Product Support Bulletin 2008-002

Maintenance of Way ~ Work Equipment Bulletin

| DATE: | February 1, 2008 | |
|------------------------|--|---------------------------------------|
| SUBJECT: | Loose Anvil Bushings – 22880062 (used on Hammers 28560624, 28560626 and 90410626) | |

Figure 1Welding 22880062 Anvil Bushing to Hammer Body

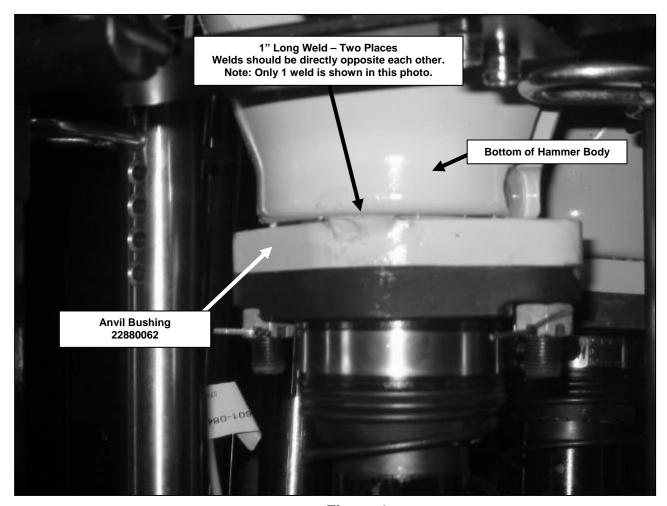
| DATE: | February 1, 2008 | |
|------------------------|--|---------------------------------------|
| OPERATIONAL IMPACT: | There have been instances of the Anvil Bushing, p/n 22880062, coming loose in the 28560624 or 28560626 Hammers. This can cause the bushing to turn or even come out of the hammer which may result in misfeeding of the spikes. | |
| | The 22880062 Anvil Bushing is flanged with 2 studs pressed into it and is press-fit into the bottom of the hammer. | |

| DATE: | February 1, 2008 | |
|------------------------|--|---------------------------------------|
| SUMMARY: | Tack weld the p/n 22880062 Anvil Bushing to the hammer body to prevent it from turning or being pulled out of the hammer. | |
| ACTION: | The bushing can be welded to the hammer body to prevent it from turning or pulling out. A weld about 1" long in two places on the bushing is sufficient. The welds should be directly opposite each other. See Figure 1 on Page 2. Make sure to follow all Lock Out-Tag Out procedures before making this repair. If the bushing needs to be removed for any reason, the weld must be ground off before removing the bushing. The bushing should be rewelded after replacement. | |
